PCN-20210227 TE0783-02 DDR3, EMMC Change and Product Update

Company	Trenz Electronic GmbH
PCN Number	PCN-20210227
Title	TE0783-02 DDR3, EMMC Change and Product Update
Subject	BOM change
Issue Date	2021-03-26

This change affects all Trenz Electronic TE0783 SoMs of revision 02: TE0783-02-*

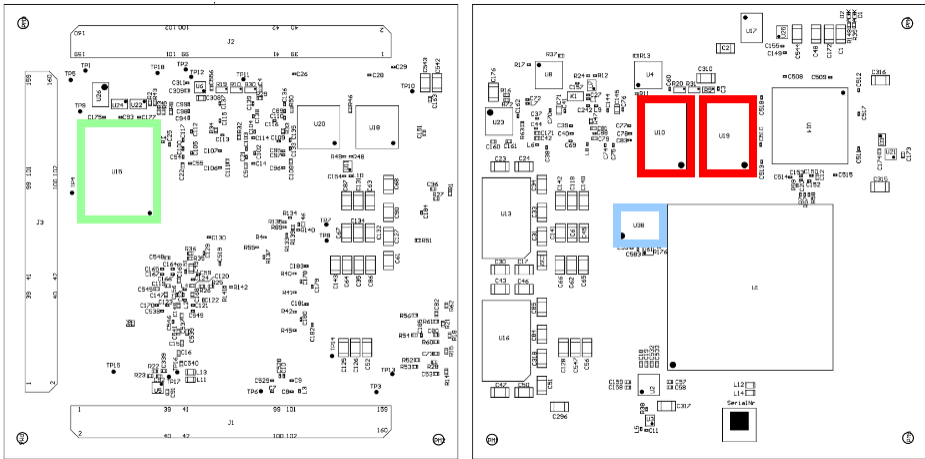
Locate DDR3 RAM (U10, U19) and Flash (U38) on bottom and eMMC (U28) on top side of PCB:

old	new
IM4G16D3FABG-125I	IS43TR16256BL-125KBLI

MTFC4GACAJCN-4M IT	IS21ES08G-JCLI

IS25LP256D-JHLE	S25FL256SAGBH120
TE0783-02-92I35HA only
